Vermont Yankee Nuclear Power Station

Proposed Technical Specification Change No. 263 – Supplement No. 9

Revised Containment Overpressure Envelope

VYC-0808, Revision 6, CCN 06

Figure 4.2 LOCA – Long Term (1.5 wt. % Containment Leakage & 100% Spray Efficiency)

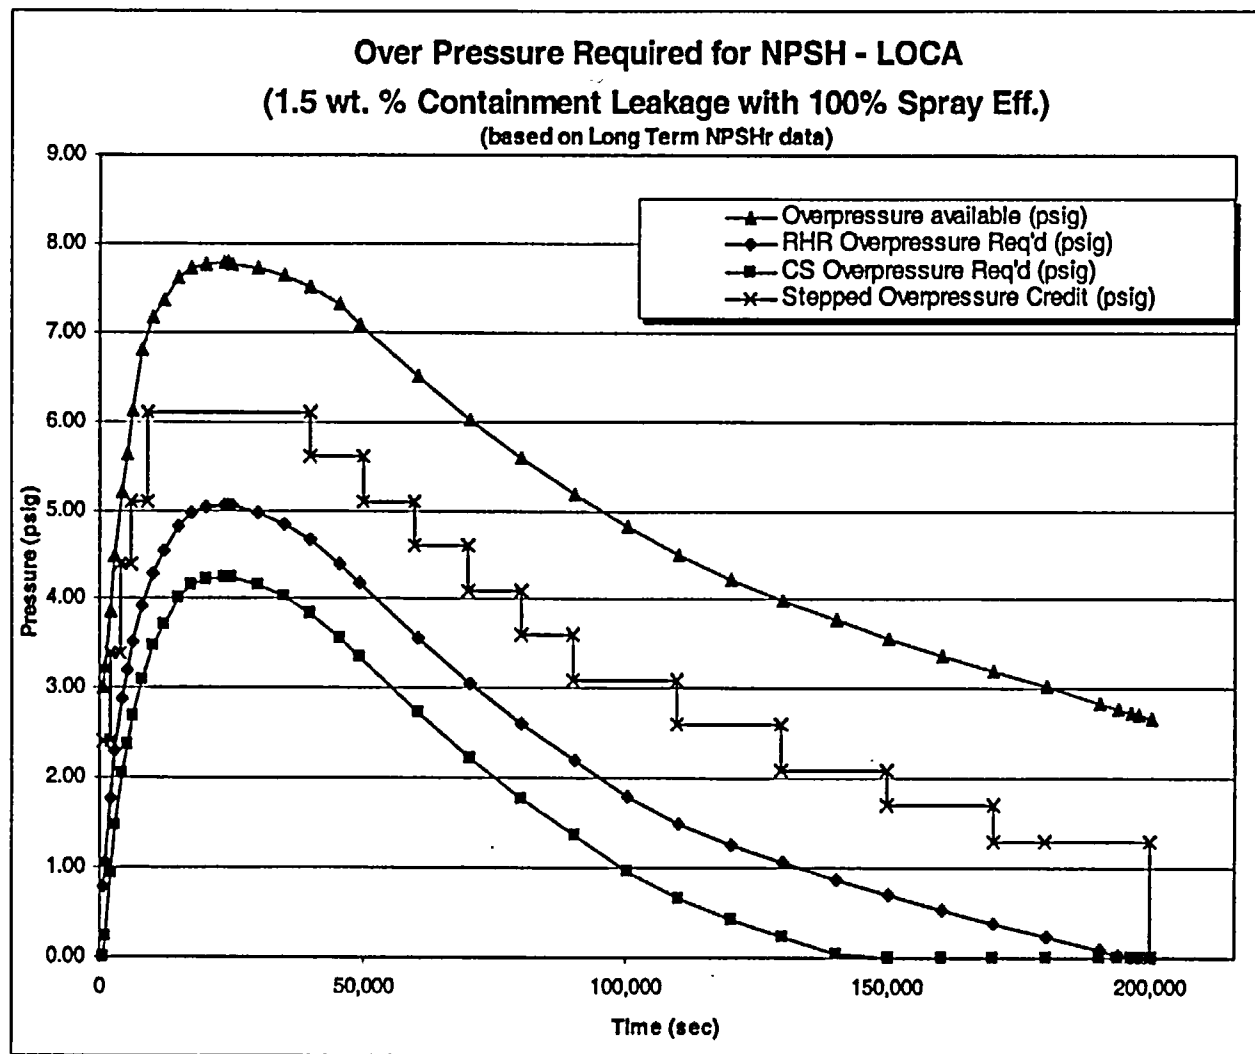
As can be seen from Figure 4.2 the overpressure required for RHR envelopes that required for CS and the overpressure varies continuously over time. In order to facilitate reporting and presentation of the overpressure required, an enveloping, stepped, overpressure credit is overlaid on Figure 4.2. Refer to Section 4.0 for discussion on selection of overpressure credit.

NPSHa is adequate for both CS and RHR pumps with an overpressure credit that varies over time, as shown in Fig. 4.2. NPSHa, OPR, OPC, OPA are shown below, at the peak temperature. The results remain unchanged from VYC-0808, Rev. 6, CCN05 (Ref. 12), LOCA long-term results, except for a slight reduction in Over Pressure Available (OPA).
